Short circuit analysis of a Doubly Fed Induction Generator and their Impact on Generator Circuit Breakers

A3 – PS1, Paper No: 10805

Figure K.1 – Equivalent circuit of a DFIM

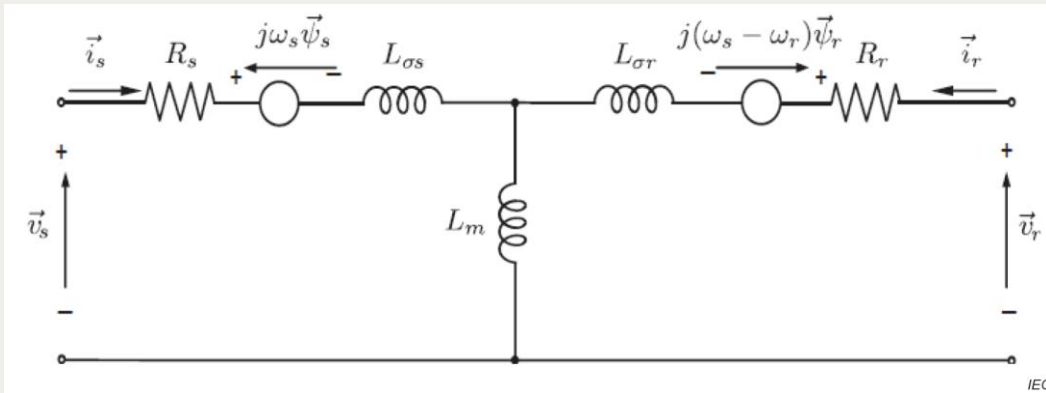
- Authors intention is not to omit this Annex in IEC/IEEE 62271-37-013. But more detailed explanation is necessary in relation the figures K.1 & K.2.
 - Mentioning of crowbar resistor is missing in K.1 and also formula of converting the crowbar resistance from rotor side to stator side while analysing short circuit behaviour on stator side. This is given in detail in paper 10805.
 - Machine details used to generate figure K.2 is missing as well. In our opinion this curve is only possible for very high crowbar resistance values which is not generally recommended in practice due to the fact that such high resistance can create a higher voltage drop across the converter which can damage it.

Key Message: Annex K needs to be further elaborated with more details.
